Dist	COUNTY	ROUTE	POST MILES TOTAL PROJECT	SHEET No.	TOTAL SHEETS
04	SF	101,1	9.2/9.8, 6.8/7.1	55	567

7 REVISED PER ADDENDUM No. 7 DATED SEPTEMBER 25, 2009

STATE OF CALIFORNIA - DEPARTMENT OF TRANSPORTATION

SC-1

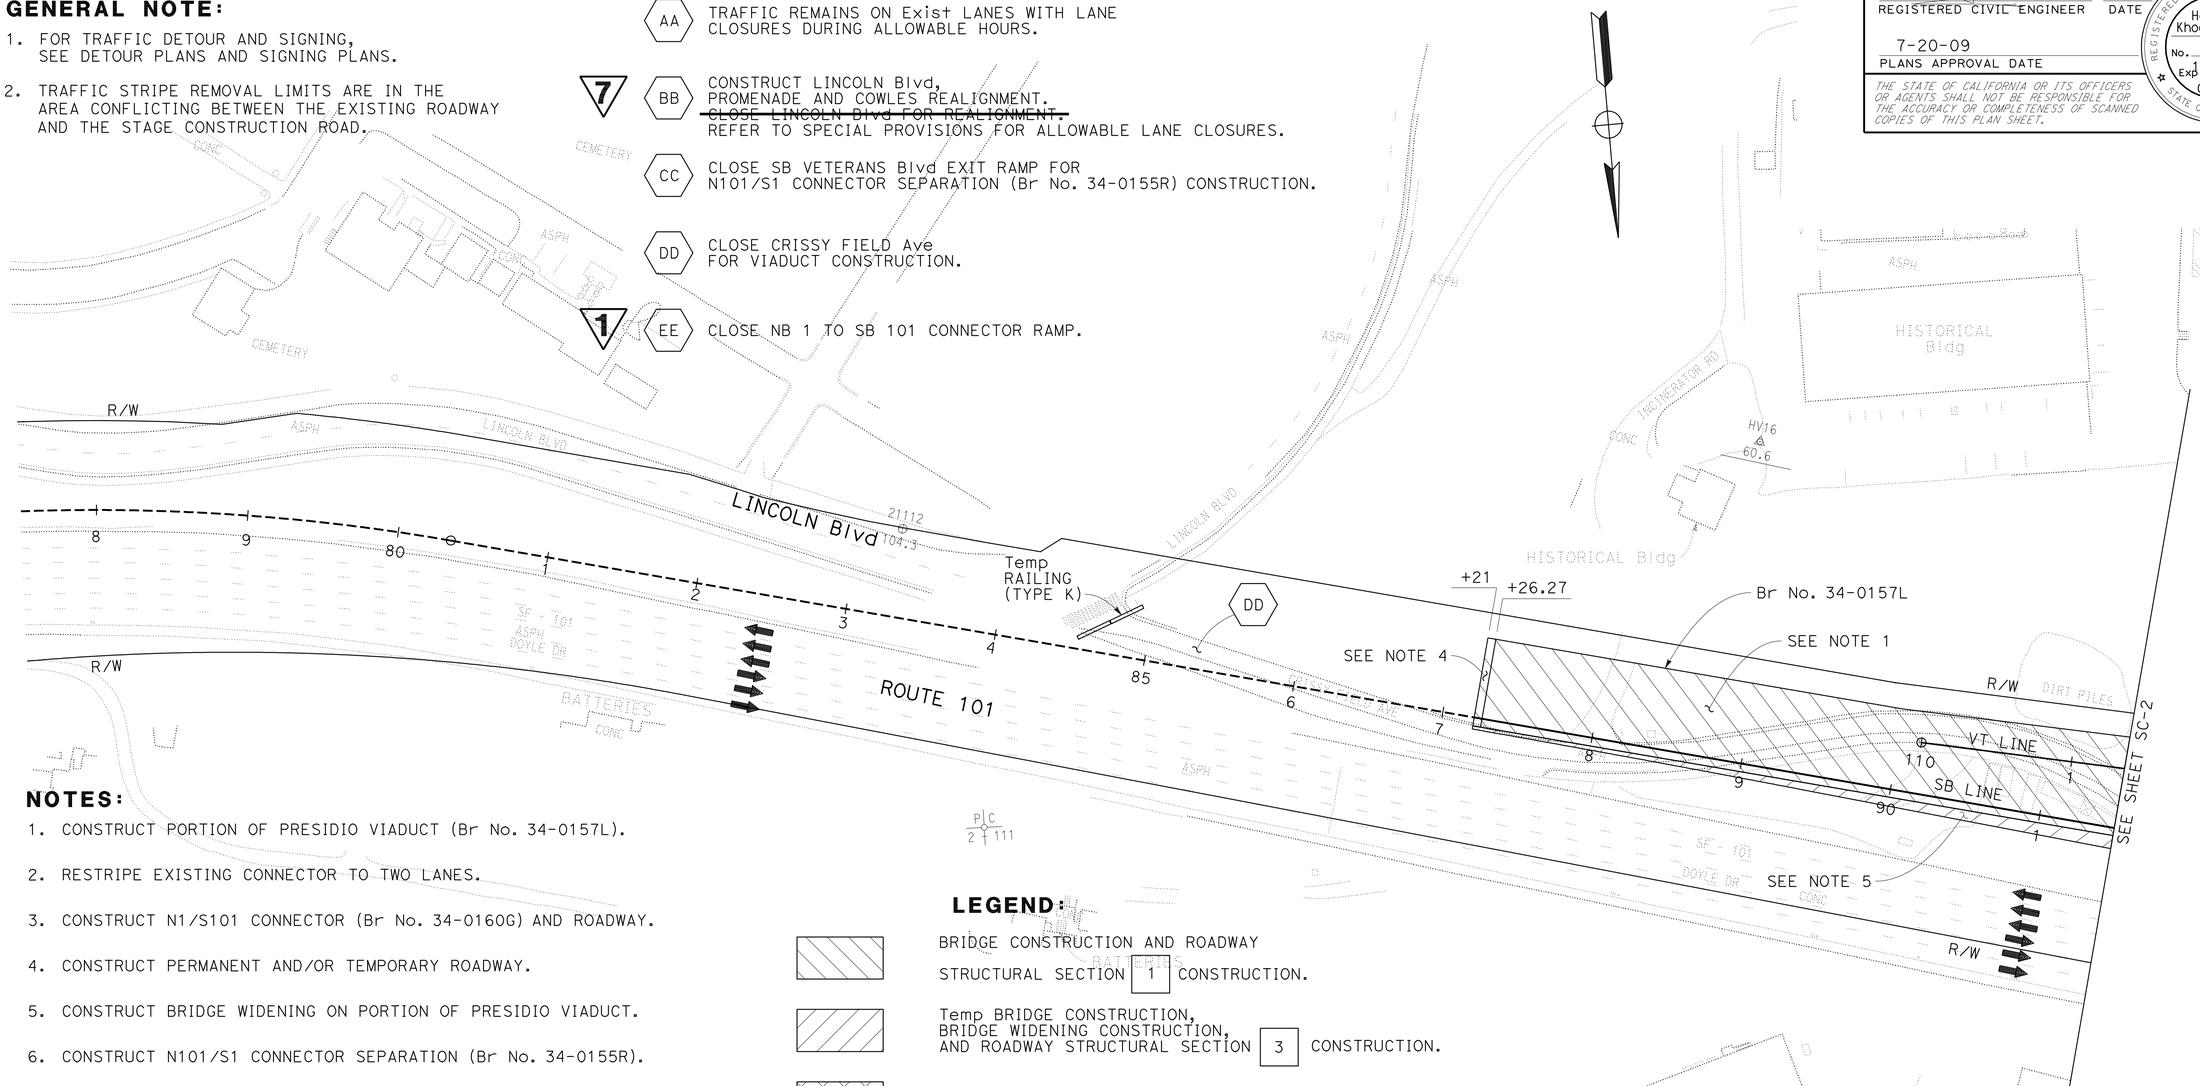
7 BB — CONSTRUCT LINCOLN Blvd, PROMENADE AND COWLES REALIGNMENT. ~~CLOSE LINCOLN Blvd FOR REALIGNMENT.~~ REFER TO SPECIAL PROVISIONS FOR ALLOWABLE LANE CLOSURES.

1 ~~12. REMOVE Exist NB 1 TO SB 101 CONNECTOR. CONTRACTOR SHALL COMPLETE CONSTRUCTION OF BRIDGE No. 34-0155R AND ROADWAY WIDENING FROM 32' Rt DTN 101160 TO 32' Rt DTN 110140 AND OPEN MAINLINE NB 101 AND SB 101 TO TRAFFIC ON STAGE 1. PHASE 3 BEFORE REMOVING NB 1 TO SB 101 CONNECTOR.~~

1 12. CONSTRUCT CIDH PILES AND OTHER SUBSTRUCTURE WORK FOR PRESIDIO VIADUCT (Br No. 34-0157L) PRIOR TO REMOVAL OF EXISTING NB 1 TO SB 101 CONNECTOR. CONSTRUCT SUPERSTRUCTURE OF PRESIDIO VIADUCT (Br No. 34-0157L) IN STAGE 1 PHASE 3 AFTER REMOVAL OF EXISTING NB 1 TO SB 101 CONNECTOR.

STAGE CONSTRUCTION AND TRAFFIC HANDLING PLAN
STAGE 2

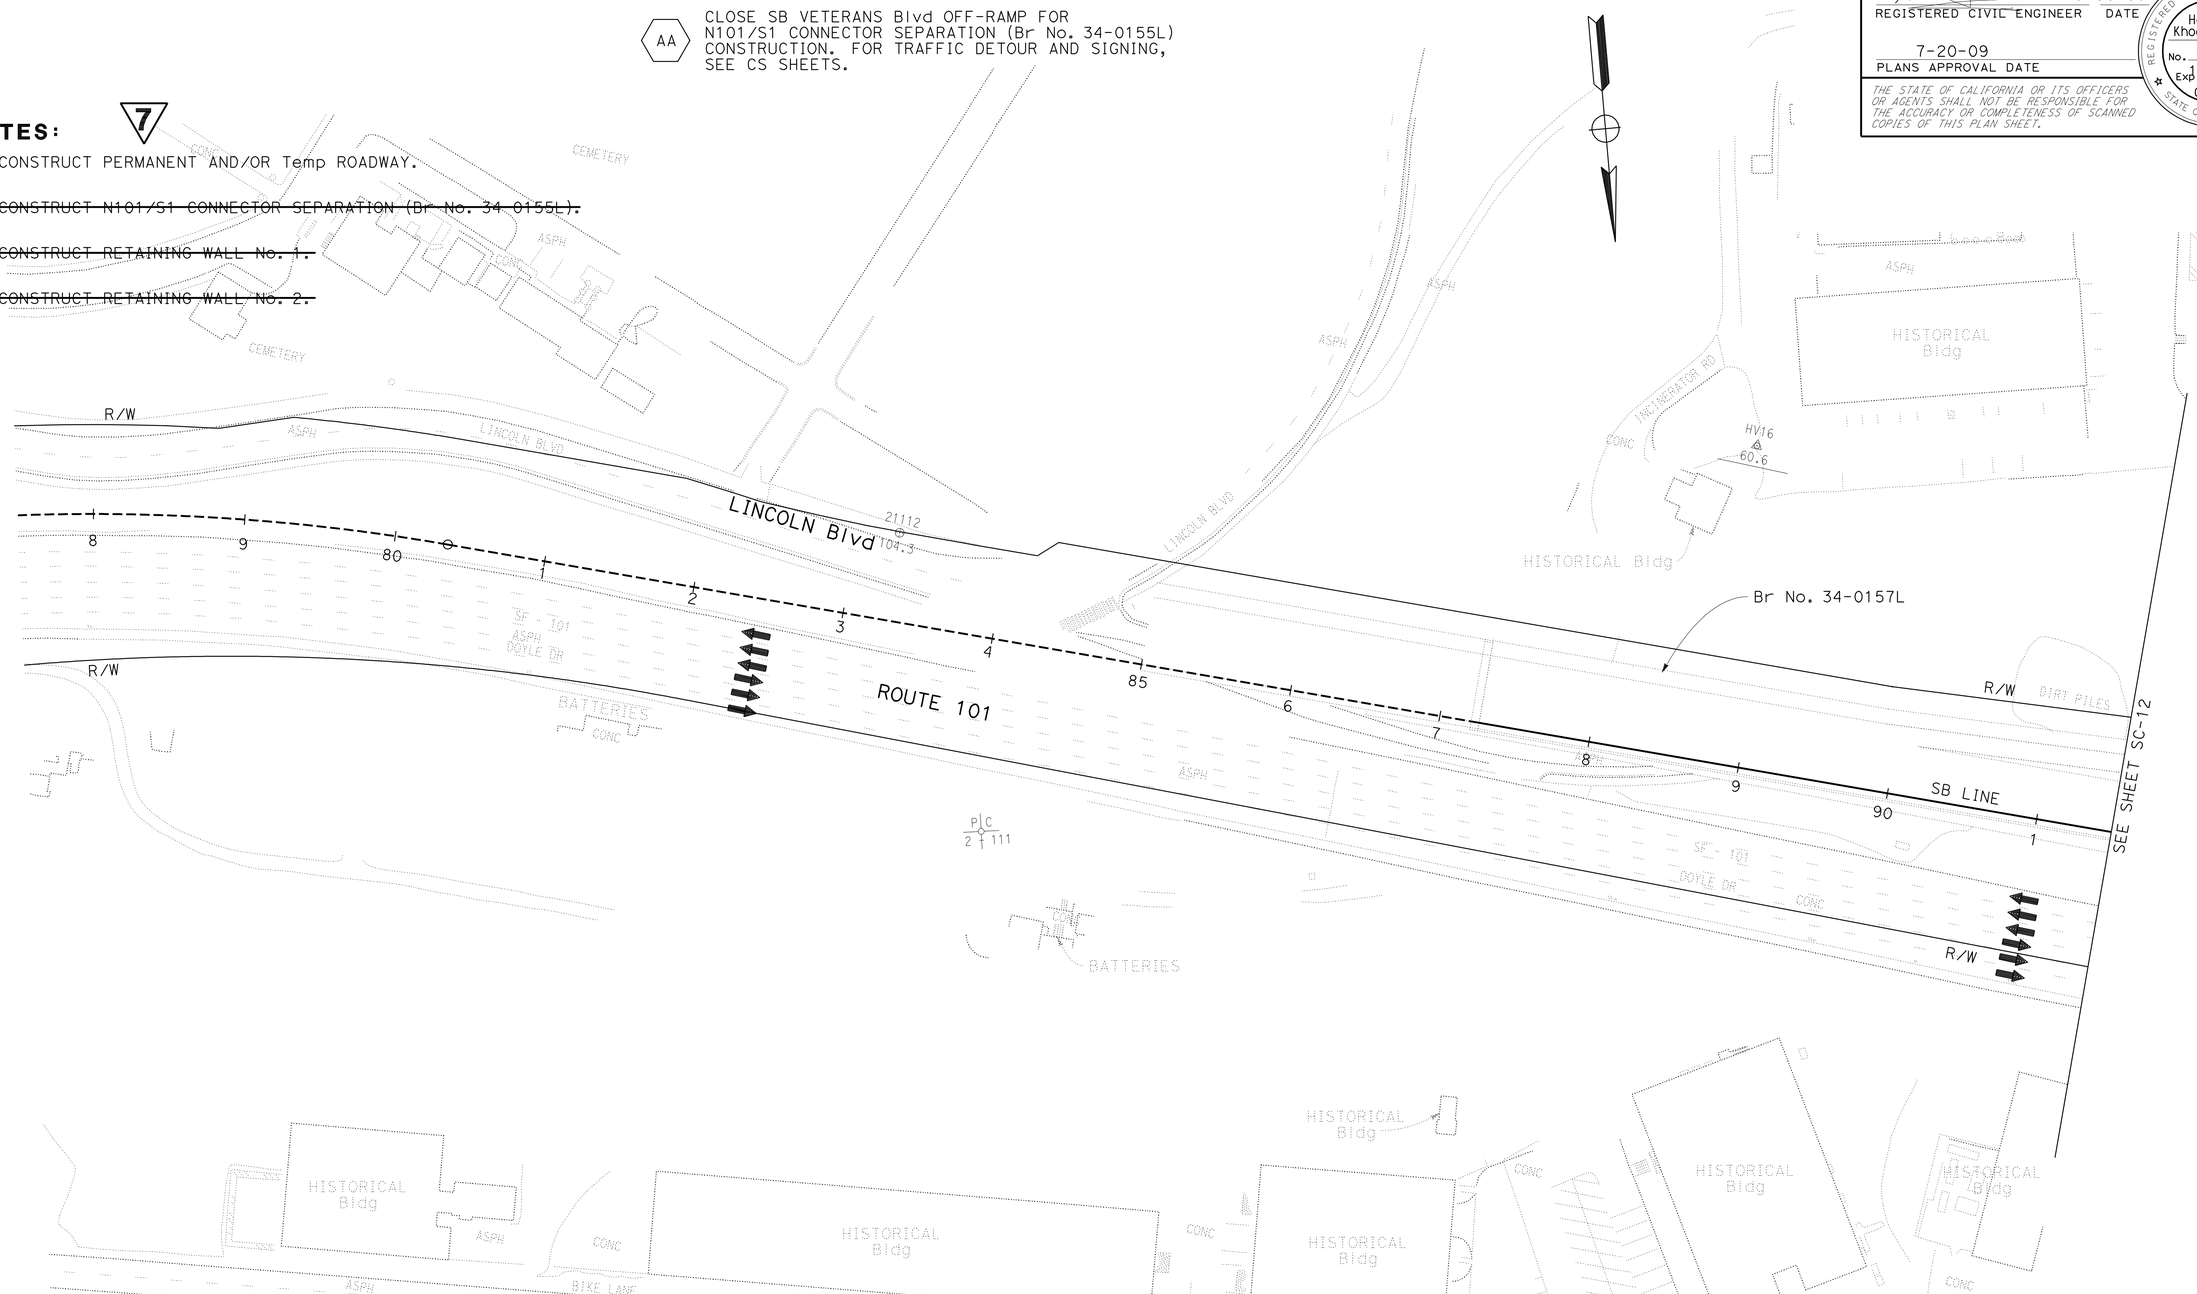
~~3. CONSTRUCT RETAINING WALL No. 1.~~

~~4. CONSTRUCT RETAINING WALL No. 2.~~

STAGE CONSTRUCTION AND TRAFFIC HANDLING PLAN

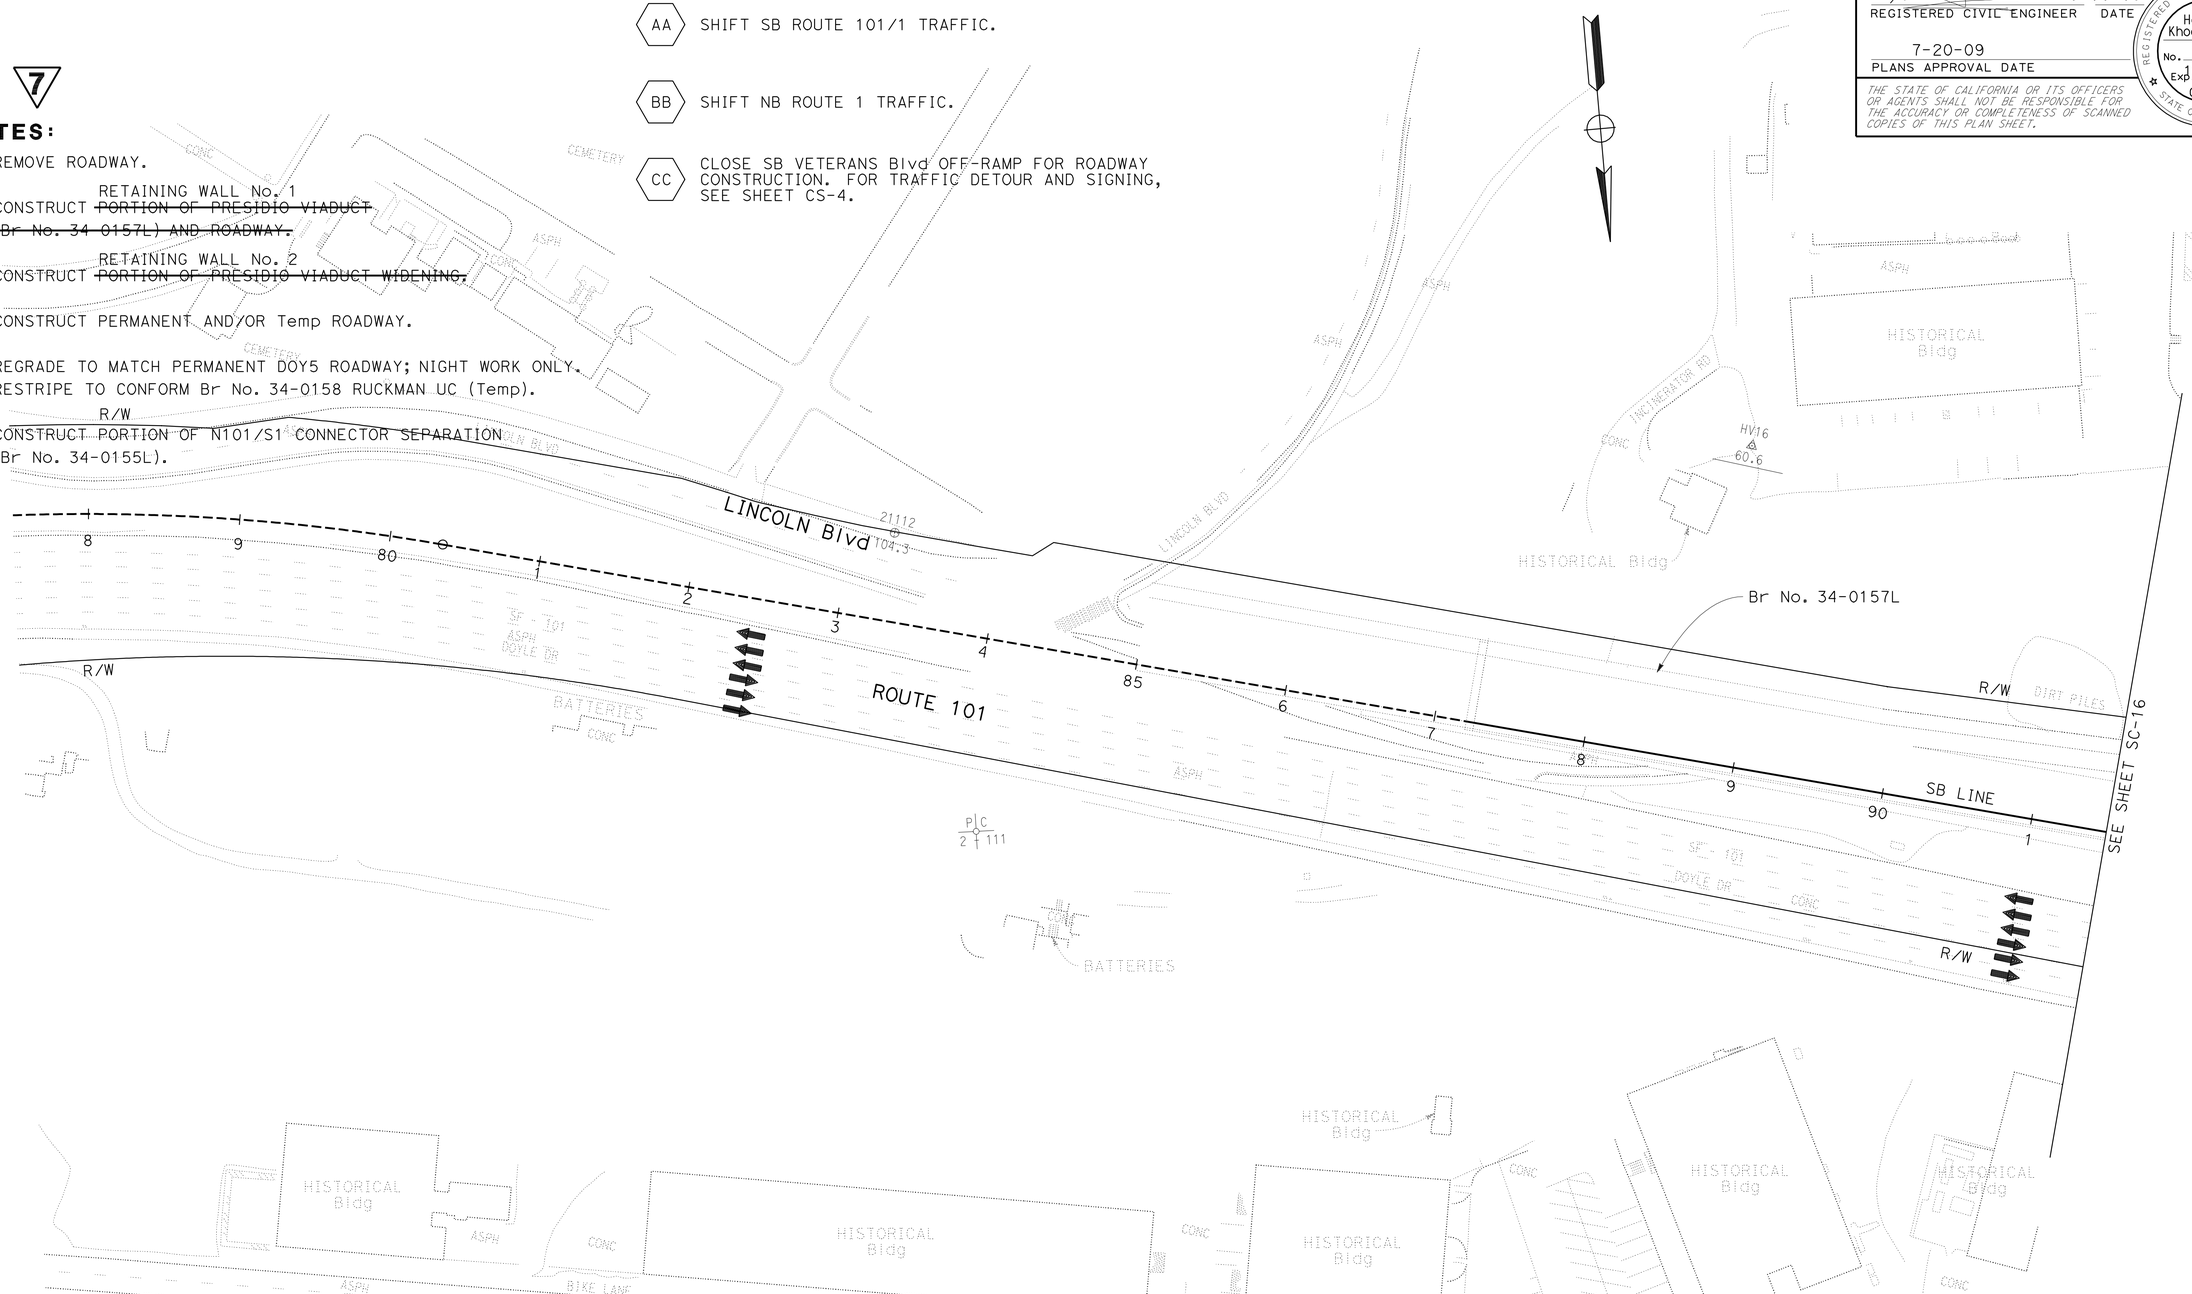
1. REMOVE ROADWAY.
2. CONSTRUCT RETAINING WALL No. 1 ~~PORTION OF PRESIDIO VIADUCT (Br No. 34-0157L) AND ROADWAY.~~
3. CONSTRUCT RETAINING WALL No. 2 ~~PORTION OF PRESIDIO VIADUCT WIDENING.~~
4. CONSTRUCT PERMANENT AND/OR Temp ROADWAY.
5. REGRADE TO MATCH PERMANENT DOY5 ROADWAY; NIGHT WORK ONLY. RESTRIPE TO CONFORM Br No. 34-0158 RUCKMAN UC (Temp).
6. CONSTRUCT PORTION OF N101/S1 CONNECTOR SEPARATION (Br No. 34-0155L).

SEE ARS CURVE 5

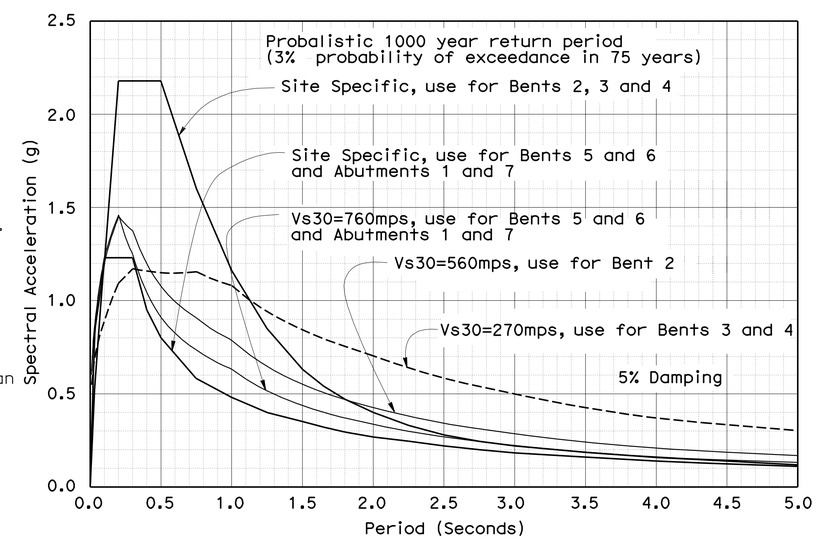
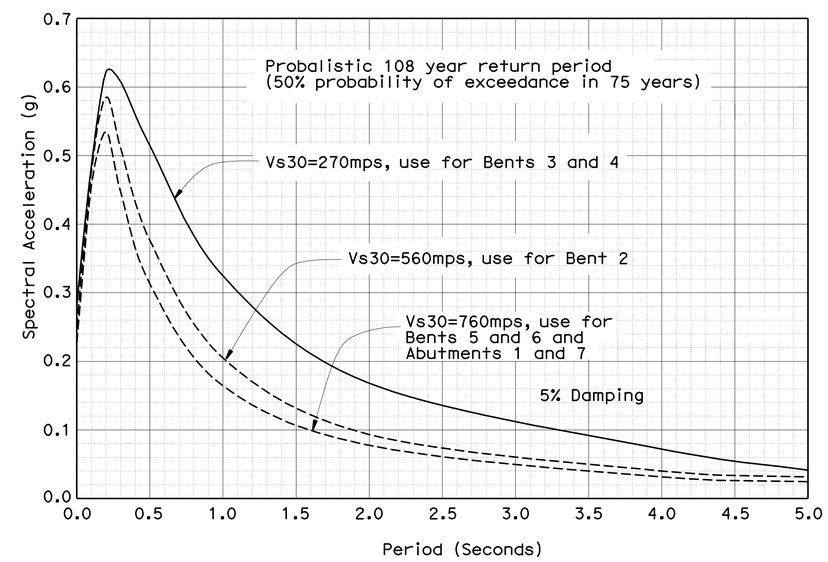
SEISMIC LOADING:
Recommended Acceleration Response Spectral curves for soil type B, C and D and Site Specific Response as shown. 5

FASTENERS: 7
- All high-strength bolts, nuts and washers shall be zinc coated.
- Bolts - A 325; Nuts - A 563; Washers - F 436, unless noted otherwise.
- All bolted connections shall comply with RCSC "Specification for Structural Joints Using ASTM A 325 or A 490 Bolts"
- All bolts are ASTM A 325 High Strength with threads excluded from shear planes.
- All bolted connections are slip critical.
- Contact surfaces of members connected by HS bolts shall be Class B coating.

Displacement Demand:
Response Spectrum Analysis
Time History Analysis (Maximum of three responses)
Site Specific Reduction factor of 0.75 is allowed 5
